HISTORIC AND DESIGN REVIEW COMMISSION

HDRC CASE NO: 2025-138
ADDRESS: 3903 N ST MARYS ST
LEGAL DESCRIPTION: NCB A49 PART OF A-2, A-4, A-52 (208 AC)
ZONING: R-5, H
CITY COUNCIL DIST.: 2
APPLICANT: Clifton Austin/Sunland Group
OWNER: Ben Barton/CITY OF SAN ANTONIO
TYPE OF WORK: Construction of a 1-story structure for coral conservation efforts
APPLICATION RECEIVED: May 21, 2025
60-DAY REVIEW: July 20, 2025
CASE MANAGER: Edward Hall

SAN ANTONIO ZOO CORAL LAB

Proposed Coral Lab
Site between the
existing Monkey
House, and
Aquarium

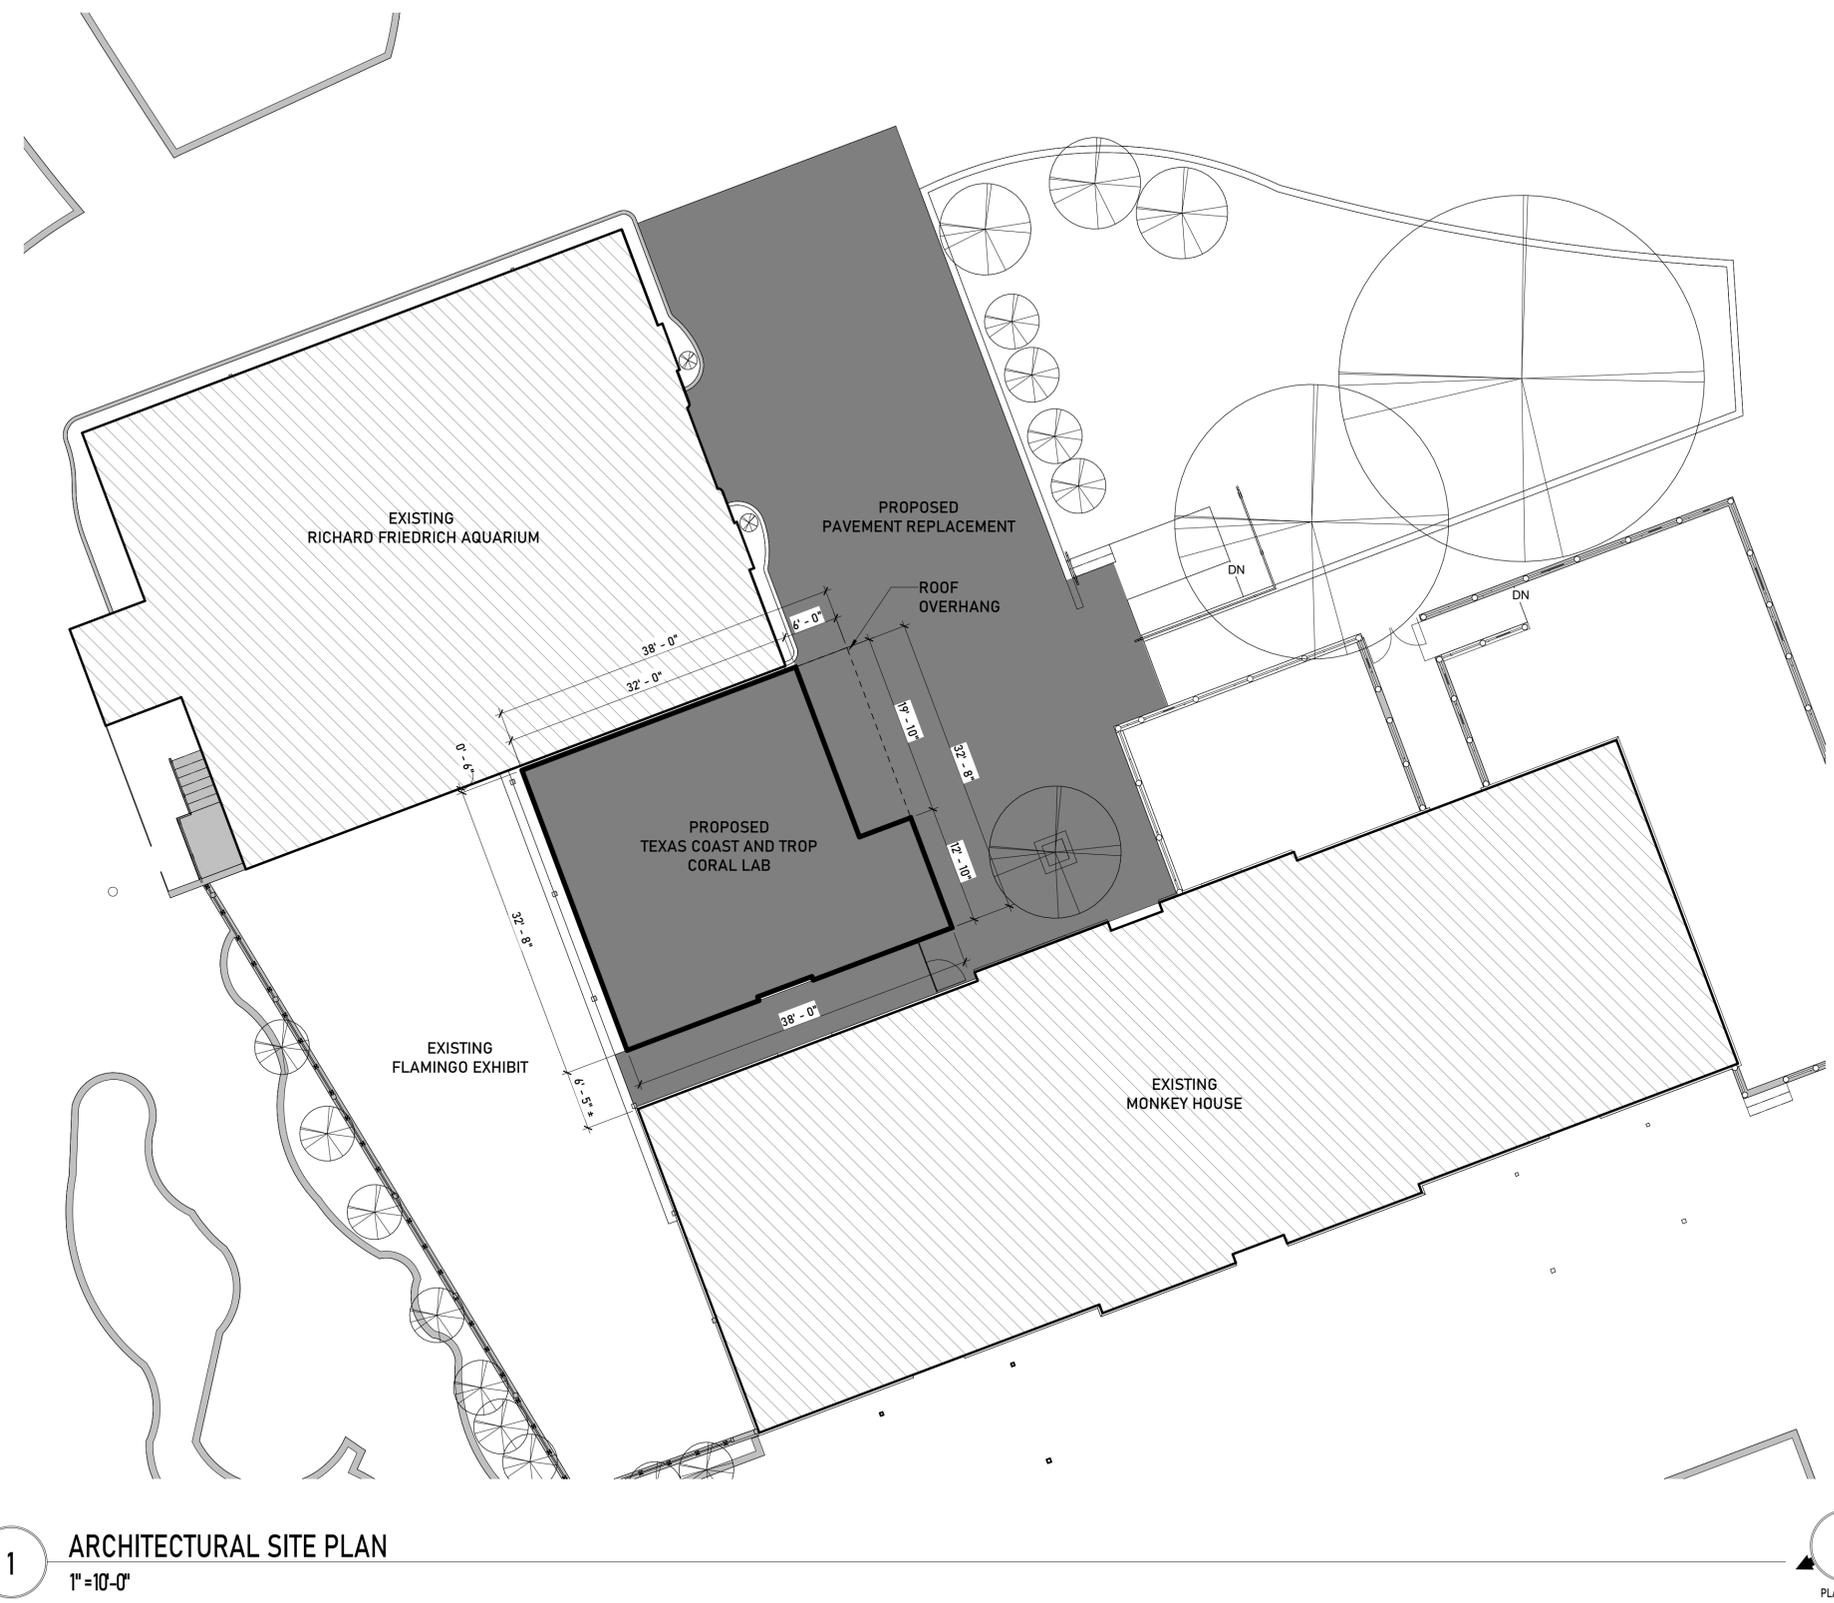
- b. EXISTING SITE – As noted in finding a, the site proposed for new construction is bordered by the Monkey House to the north, the Aquarium to the south and the Flamingo Habitat to the east. This site is currently occupied by an enclosed landscaping area with a low wall and a portable storage building.
